# City of Tualatin

## ARCHITECTURAL REVIEW FINDINGS AND DECISION

### \*\* APPROVAL WITH CONDITIONS \*\*

Case #: AR-17-0009  
 Project: Air Liquide Gas Depot  
 Location: [10500 SW Tualatin-Sherwood Road](#)  
 (Tax Lot: 2S126B000105)  
 Applicant: Matt Oullette, 131 Third Ave. Longview, Washington 98632  
 Project Contact: Eric Lanciault 3200 SE 164<sup>th</sup> Ave., suite 302 Vancouver, WA 98683

**1 PLAN @ OFFICE BLDG #300**  
1/4" = 1'-0"

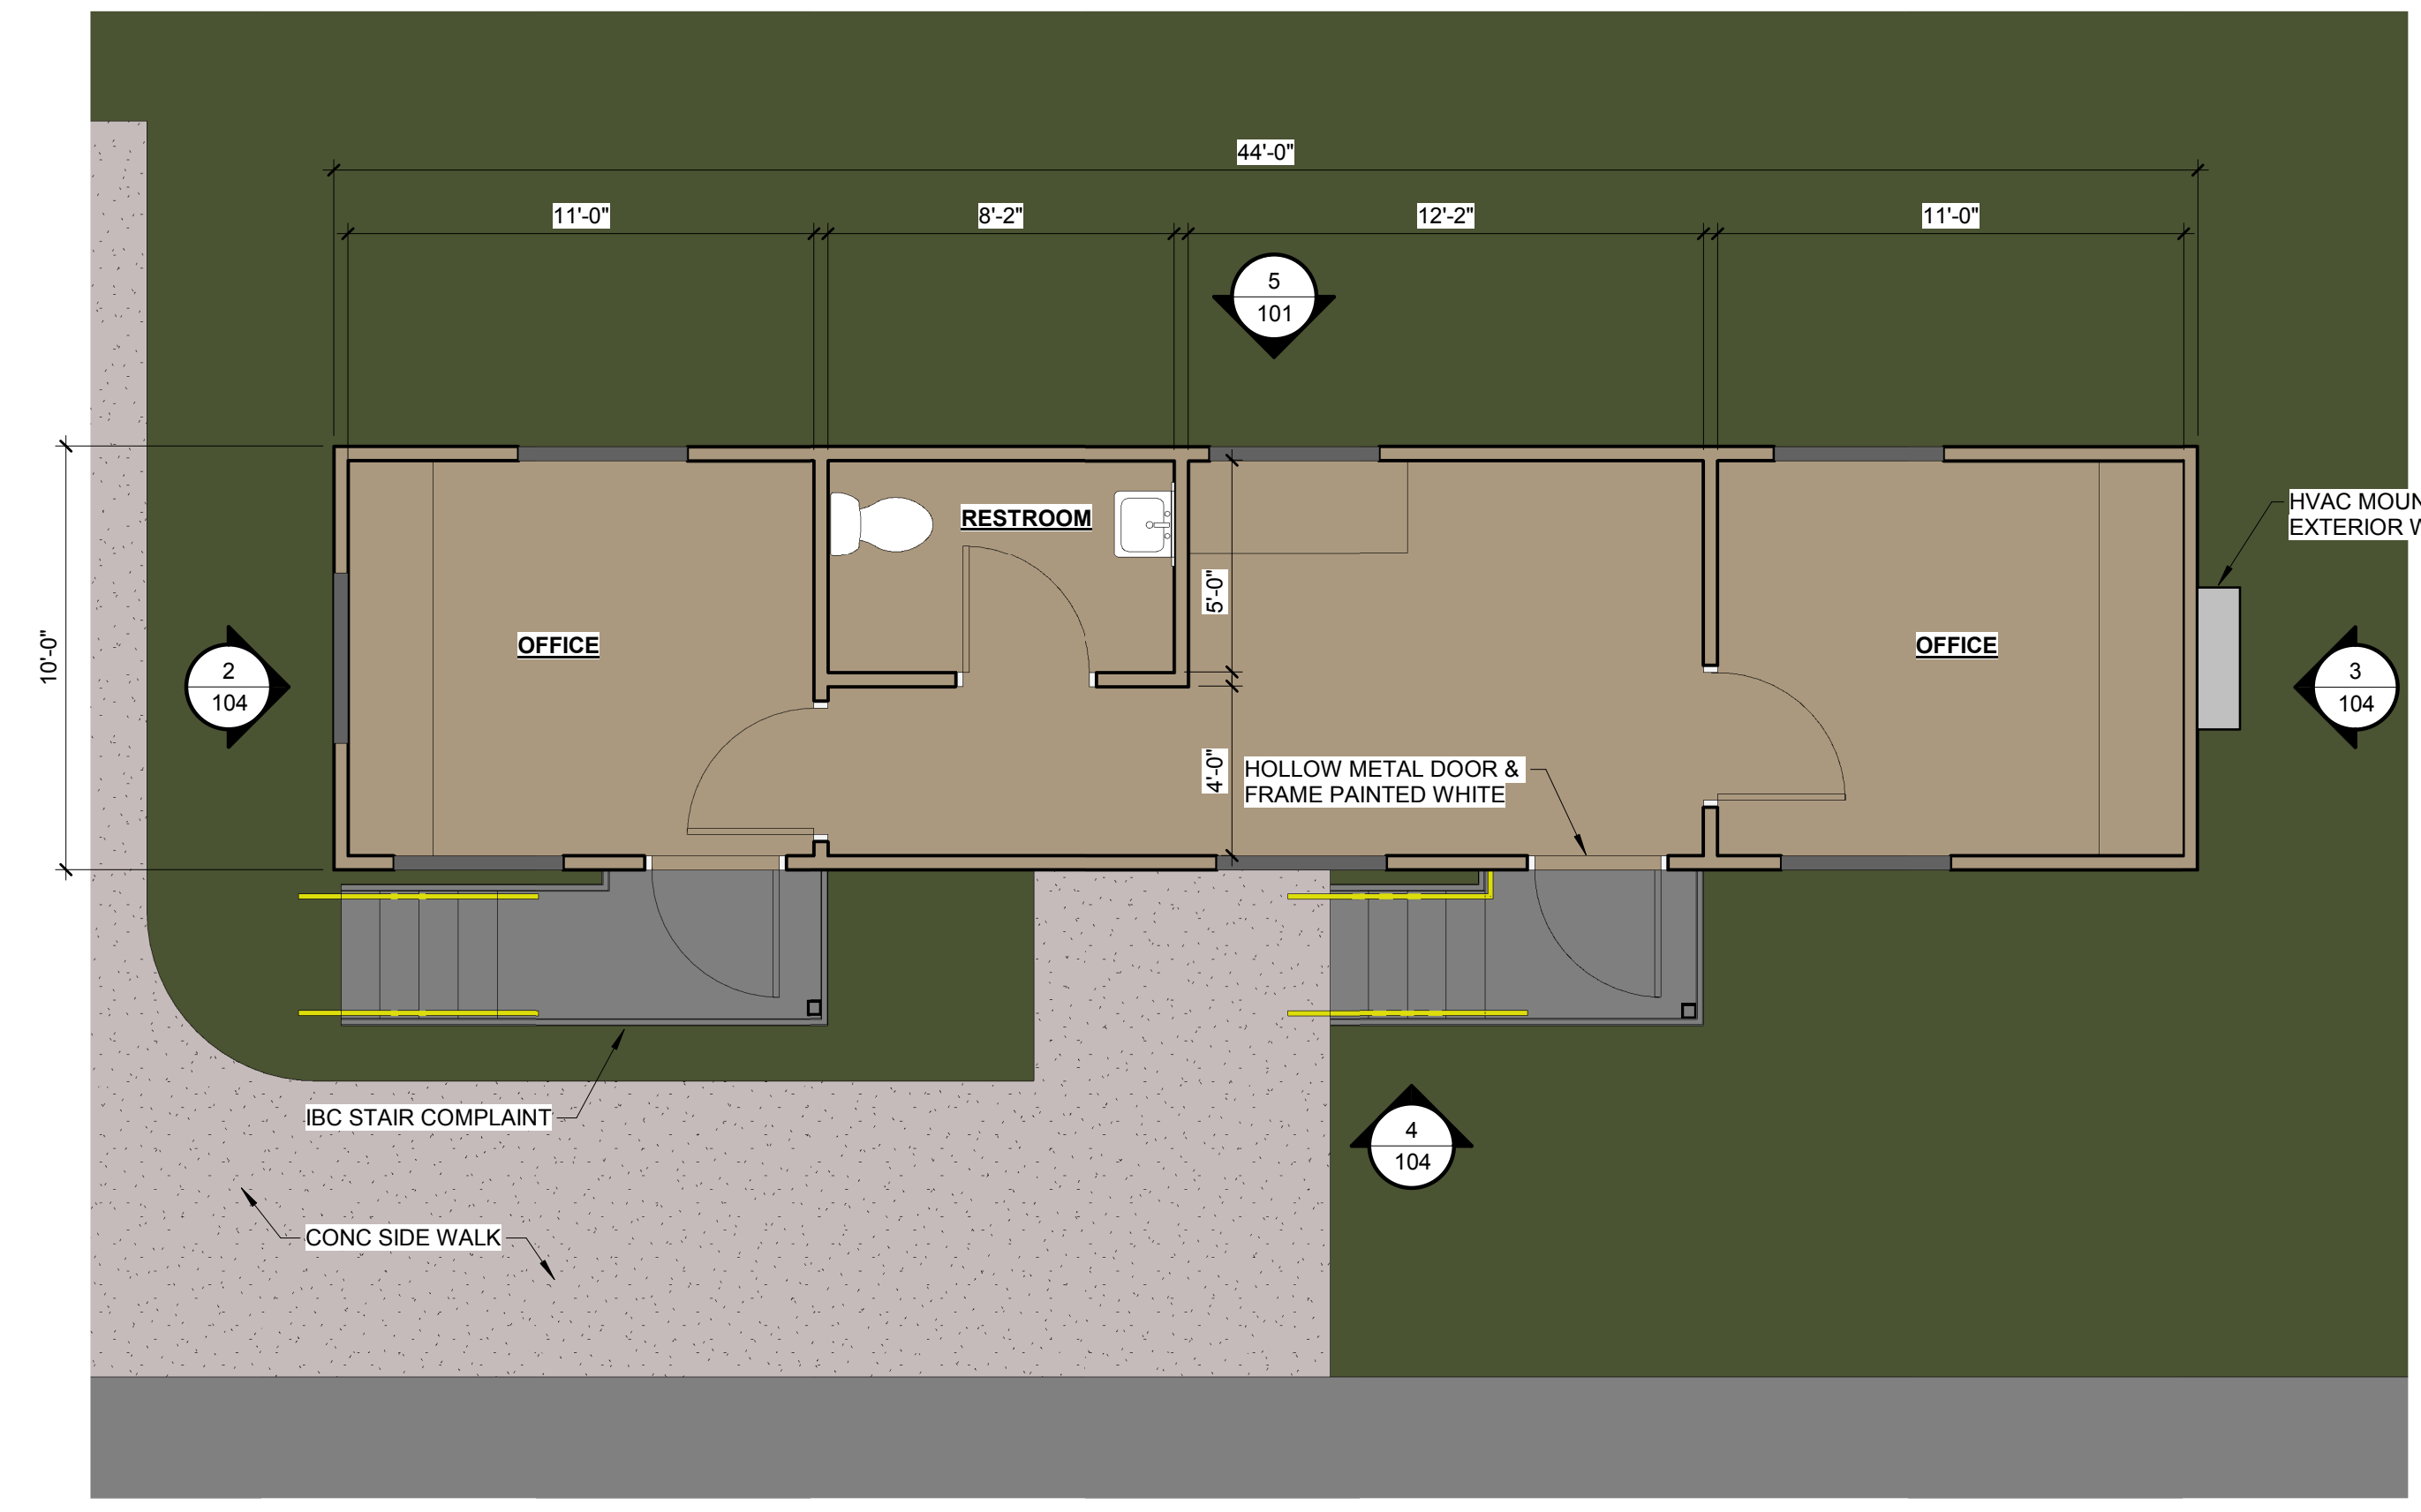
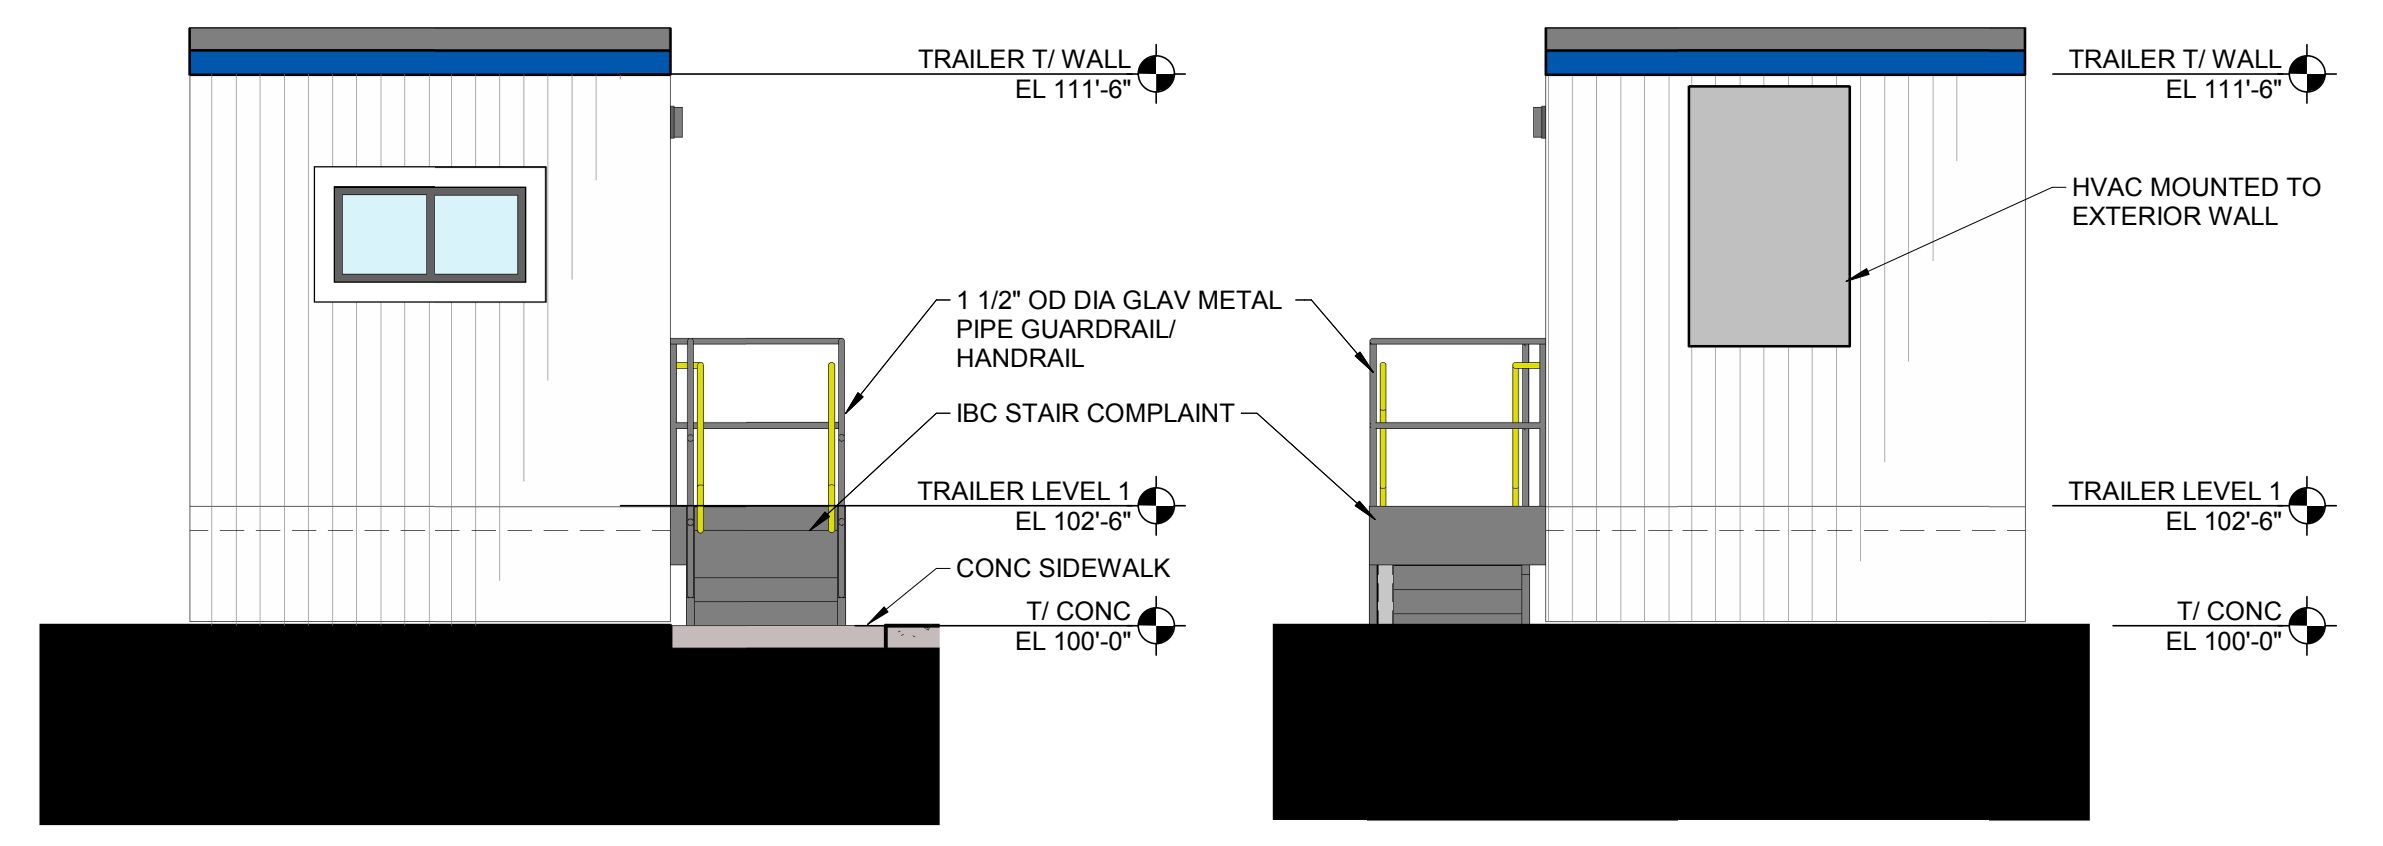
*Staff notes that sidewalks are proposed to connect pedestrian walkways from the parking areas and public rights-of-way. Two ADA stalls are also being proposed. The office trailer features two entry doors, both of which have stair access, no ramps are shown on the plans. A condition of approval has been added to require at least one ramp for trailer access. Additionally, the placement of the trailer will require a building permit which will be reviewed by the Building Department for full ADA compliance.*

Condition of Approval: The applicant shall revise the plans to show at least one access ramp into the office trailer, and install the ramp prior to occupancy.

**SHEET NUMBER**  
**L1.0**

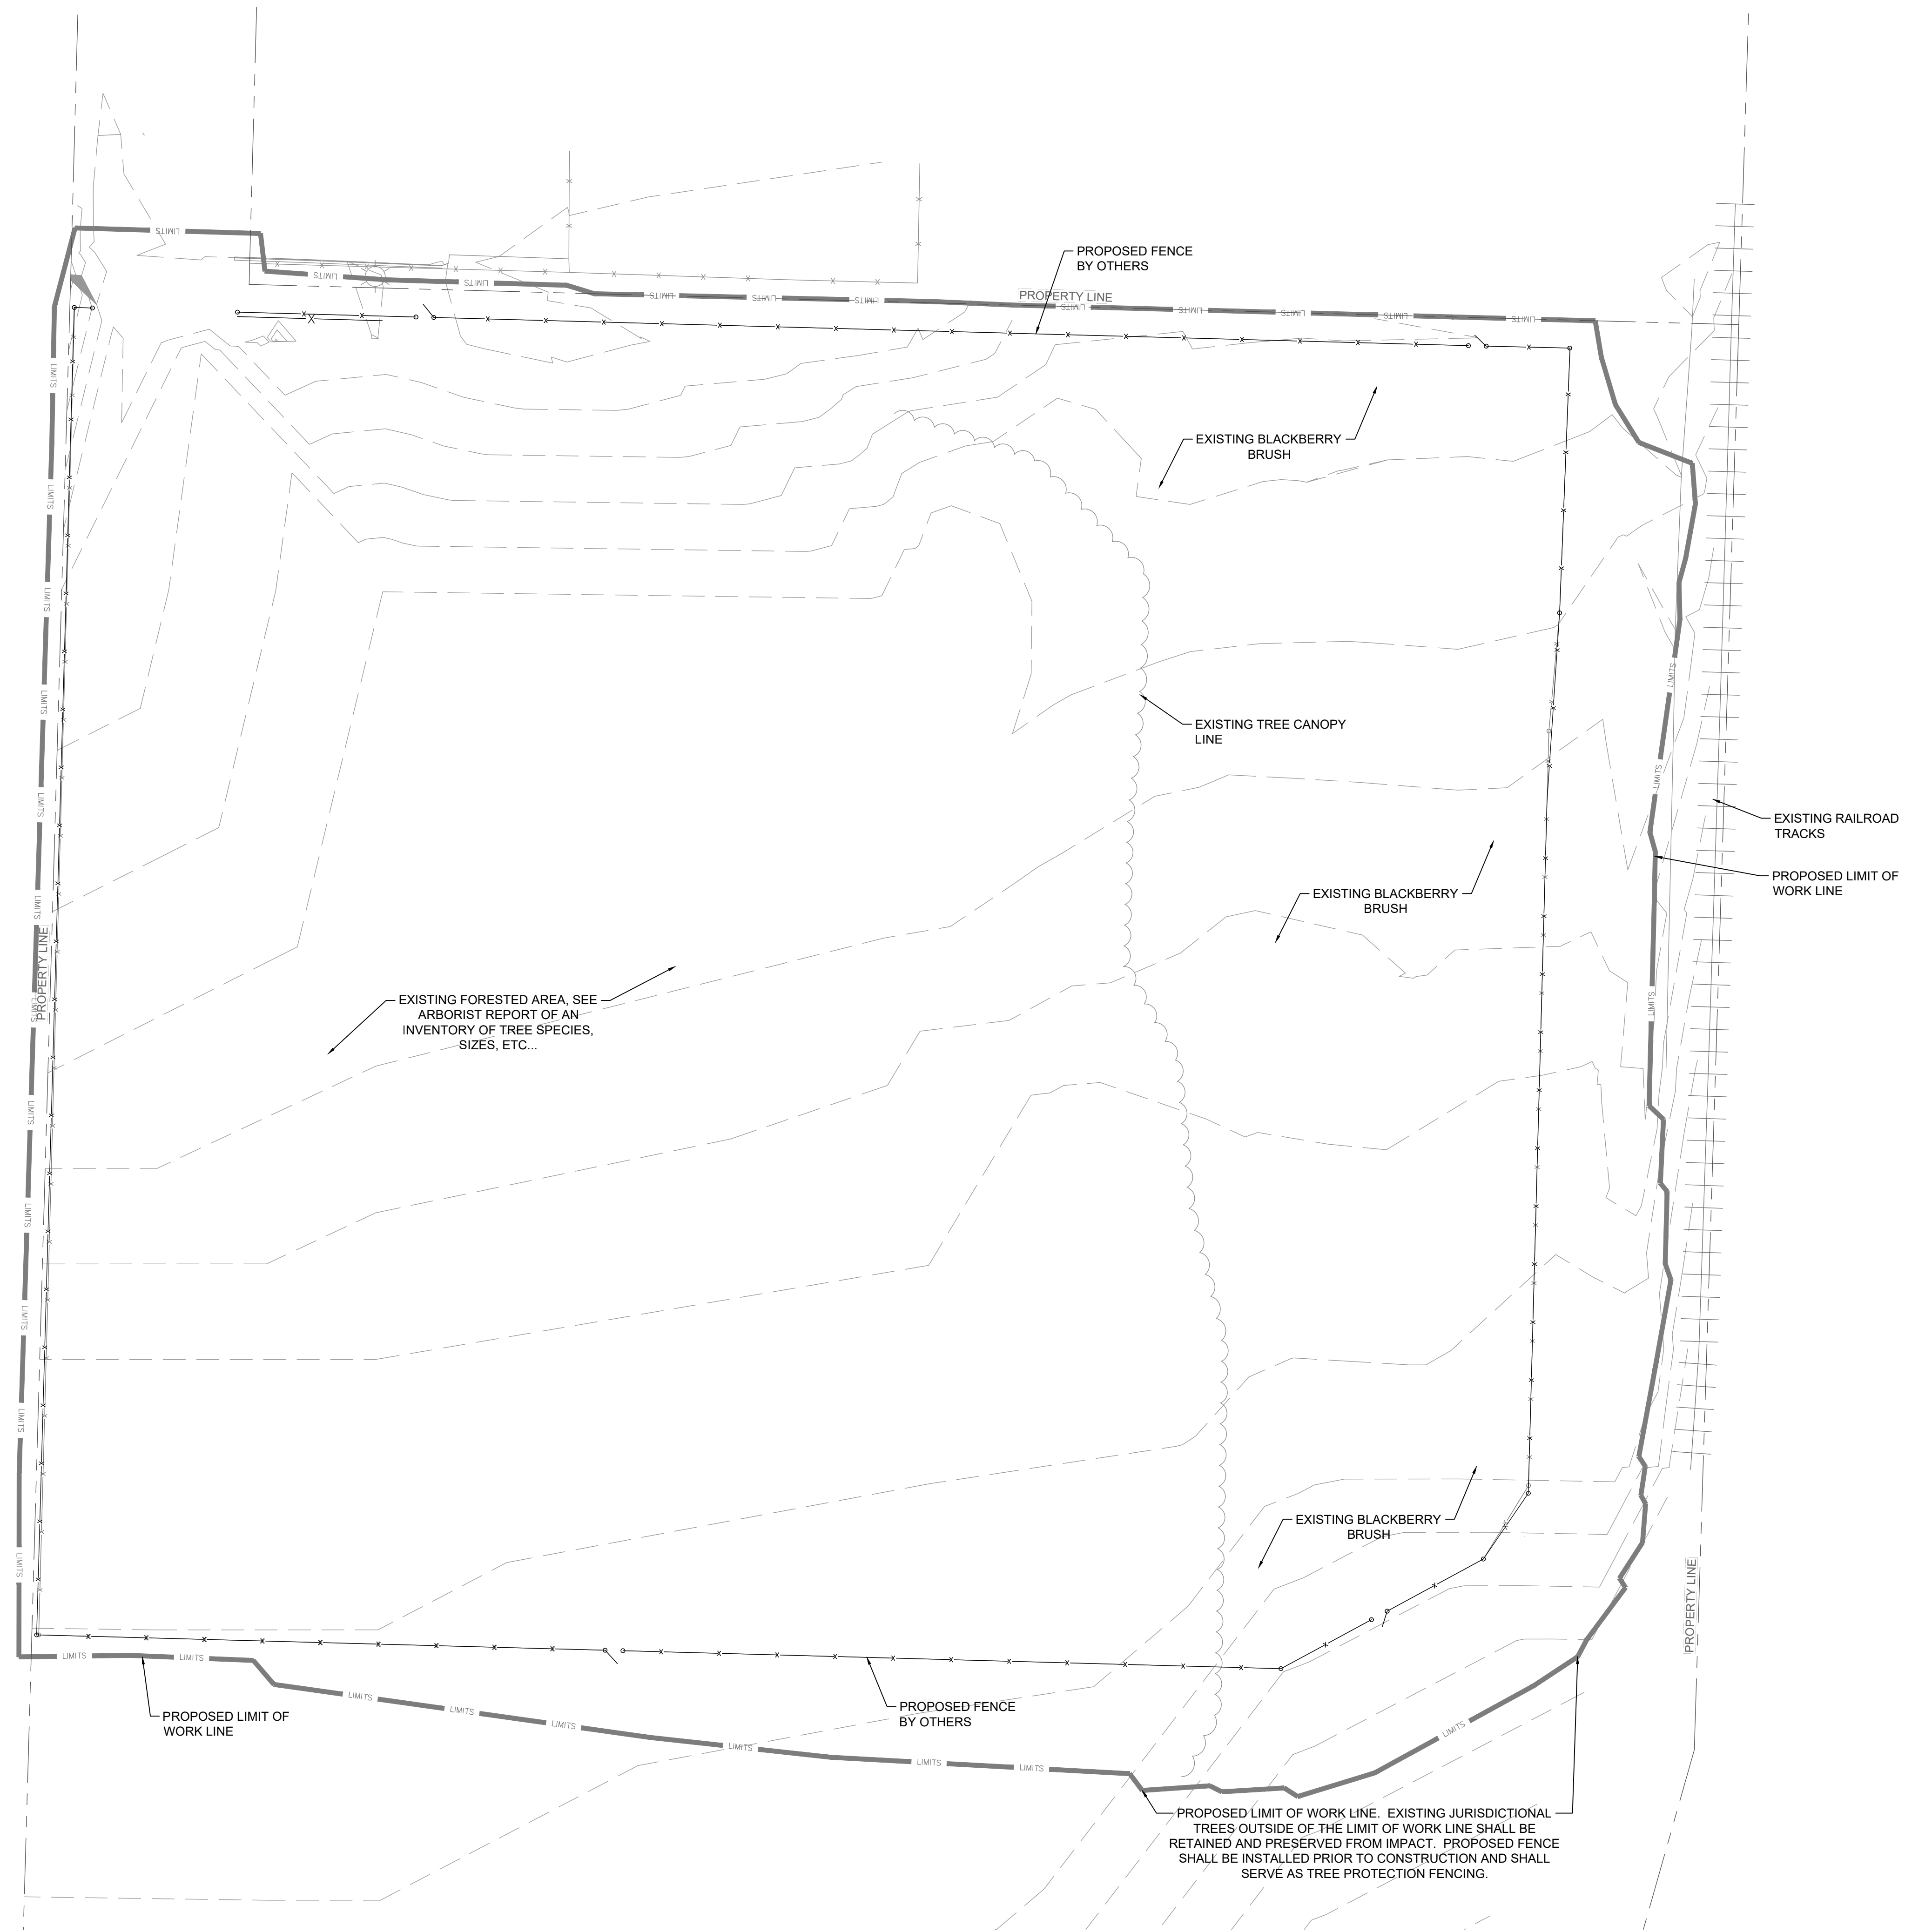
*Staff notes this specification is included on the Landscape Plan (sheet L1.0, dated 10/5/17). The shrubs surrounding the parking area are called out as Goldflame Spirea with an average height of 15" the trees are called out as Incense Cedar and European Hornbeams. A note has been added under the conditions of approval that states landscaping must be continually maintained in a manner substantially similar to that originally approved by the AR decision. This standard is met.*

*The Landscape Plans, sheets L 1.0 and L 1.2 demonstrate that with adequate maintenance, the ground will be covered in plantings within three years of planting. Note 16 on the plans explains that the landscape plans and the applicant are required to assure the standards from the code are maintained. This standard is met.*

*According to the Landscape plans sheet L1.0 the minimum 5 feet of landscaping has been provided around structures. This standard is met.*
